In the Matter of)
)
PRIVATE FUEL STORAGE, L.L.C.) Docket No. 72-22-ISFSI
)
(Independent Spent Fuel)
Storage Installation))

NRC STAFF'S STATEMENT OF ITS POSITION
CONCERNING GROUP I-II CONTENTIONS

NRC STAFF POSITION ON GROUP I AND II CONTENTIONS

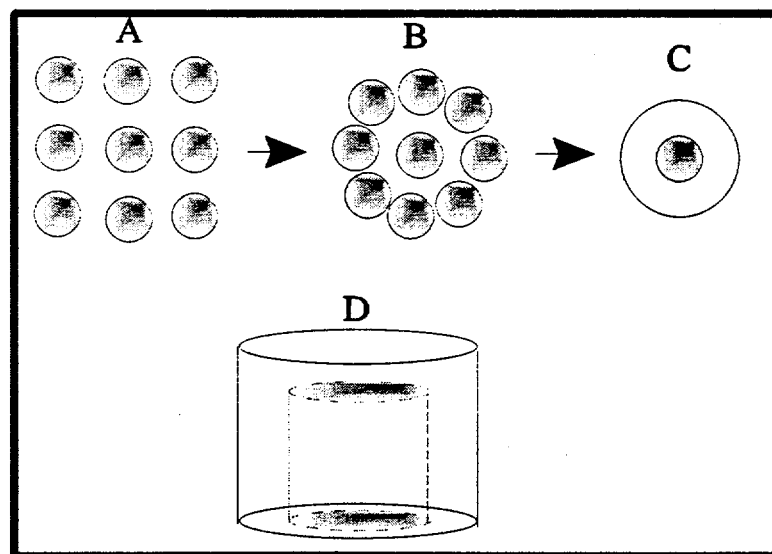
3. PFS's projection that average daily temperatures will not exceed 100°F fails to take into account the heat stored and radiated by the concrete pad and storage cylinders.

4. In projecting ambient temperatures, PFS fails to take into consideration the heat generated by the casks themselves.

The Staff then reviewed changes to those input, as they relate to the 125 degree F analysis. The Staff found those input to be bounding and appropriate. For example, as illustrated in the following figure, Holtec simulated the impact of neighboring casks by a hypothetical shell surrounding the cask. The impact of neighboring casks (e.g., Array A, below), can be bounded by encircling the neighboring casks around the center cask (Array B, below). This can be further simplified by simulating the contribution of the neighboring casks with an equivalent cylinder, as illustrated in Array C, below. Array D provides a side view representation of the calculation performed by Holtec. The inside surface of the hypothetical shell is modeled as a reflecting boundary which simulates the radiant energy input from the surrounding casks. In addition, the hypothetical cylinder does not permit air to flow from the radial direction (between the neighboring casks). This requires the ambient air to enter from above, traveling down the annulus formed by the HI-STORM overpack and the hypothetical cylinder. The Staff questioned Holtec on the method used to calculate the distance between the outer surface of the overpack and the inner shell of the hypothetical cylinder. For this arrangement, one would assume the use of an equivalent heated diameter. Holtec agreed that an accurate thermal-hydraulic representation of the hypothetical cylinder diameter is derived by using four times the area divided by the heated perimeter. With the use of bounding assumptions, the equivalent diameter used in Holtec's evaluation was significantly less than would be obtained using the equivalent heated diameter. This assumption provides greater resistance for air circulation and increases the temperature of the cask and the ambient air as it travels toward the bottom of the overpack. The Staff found Holtec's assumption to be acceptable. In addition, at the Staff's request, Holtec performed a sensitivity study that assumed no sunset (i.e., the sun was assumed to shine on the overpack 24 hours per day). With this bounding assumption, the peak cladding temperature remained below the fuel design short-term temperature limit.

Holtec's thermal analysis was performed with a bounding ambient temperature of 125°F. The bounding analysis assumed that the 125°F ambient temperature plus solar heat input from the sun were held constant until steady-state cask temperature profiles were established (in reality, the peak ambient temperature and sun input would exist for a short duration, compared to the time required to obtain steady-state temperature profiles). These analyses incorporated radiation from the concrete pad and neighboring storage cylinders. The results of the analysis were well below the temperature limit for the clad, canister shell and cask surface. The Staff has found these bounding analyses to be acceptable.

Holtec's analyses calculated the impact of radiant heat transfer from the cask surface, as well as the radiant heat transfer interaction between neighboring casks and the concrete mat upon which the casks will be placed.

The Staff reviewed the assumptions or inputs used in Holtec's Thermal Analysis ("EHT"), dated February 9, 1999. The input was reviewed in detail for the 100 degree F ambient temperature case.
